Intel® 82371AB (PIIX4)

Specification Update

April 1999

Order Number: 297738-011

QUEUE HEAD LINK POINTER (DWORD 0: 00-03h)

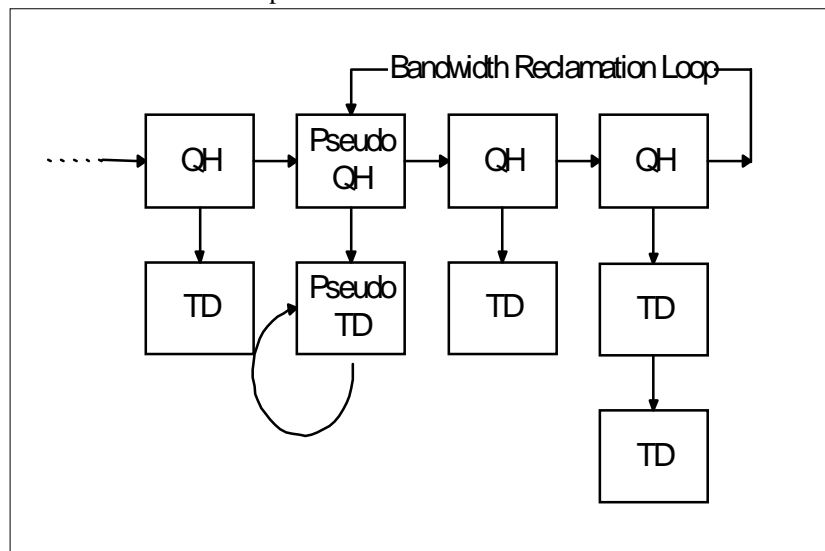
Workaround: When using bandwidth reclamation, the UHCI driver should insert a pseudo queue head with a pseudo transfer descriptor within the bandwidth reclamation loop. The PIIX4 will fetch this queue head and transfer descriptor on every frame, but will not transfer any data and will never be terminated. The following bits must be properly set to implement the workaround:

The Queue Head Link Pointer (QHLP=bits [31:4]) must be set to point to the pseudo TD.

The QH/TD Select (Q=bit 1) must be set to 1 indicating it is a QH.

The Terminate bit (T=bit 0) must be set to 0 indicating that the link pointer field points to a valid TD.
